SAFETY RECALL CODE 0827 - THROTTLE CONTROL SYSTEM

The Buell Motorcycle Company has determined that a defect related to motor vehicle safety exists in the throttle control system of the 1999 and certain 2000 model year fuel injected motorcycles identified below. The idle control cable can become dislodged from the fuel injection system cable guide due to improper adjustment of the throttle control system. Should this occur, the throttle may not return to the idle position when the operator's hand is removed from the twist grip, but will return with light hand pressure applied.

Figure 1. Throttle Cable Clamp Installed

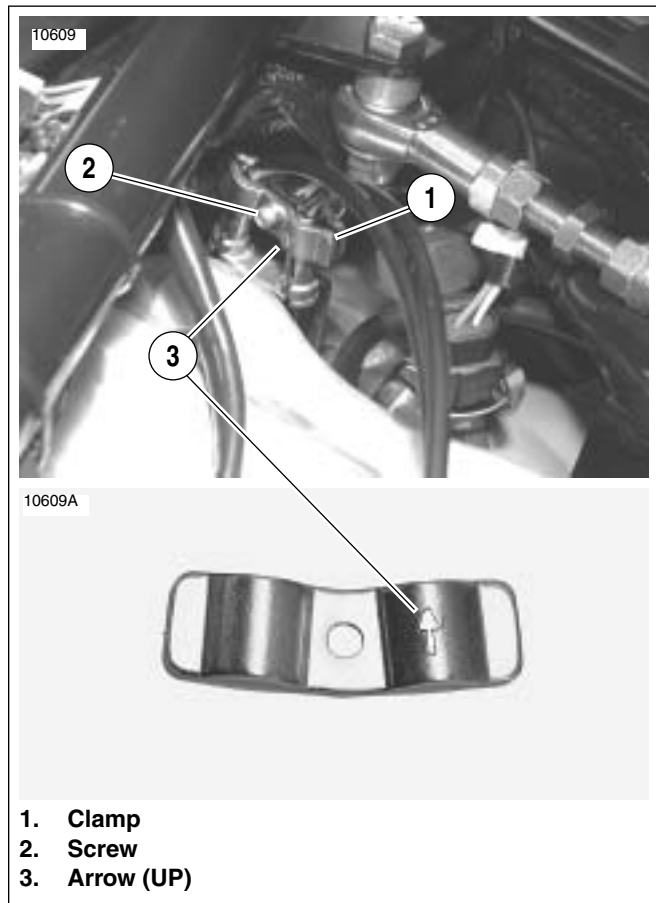
4. Remove fuel tank. Refer to Service Manual sections indicated above for fuel tank removal/installation instructions.
5. Verify correct throttle cable adjustment.
6. See Figure 1. Apply Loctite 242 to fastener and loosely install cable clamp (1) over throttle cables and slide down to the cable ends.

Do not install cable clamp over the cable guide bracket. This will not allow the clamp to tighten properly onto the throttle cables.

Throttle clamp is directional. Please note arrow (3) on right side of clamp which points straight up when properly installed.

7. With cable clamp in place tighten fastener (2) to 24-27 in-lbs (2.7-3.0 Nm).
8. Verify proper throttle operation.
9. Install fuel tank. Refer to Service Manual sections indicated above for fuel tank removal/installation instructions.
10. Install vapor vent hose on vent hose fitting and install cable strap.
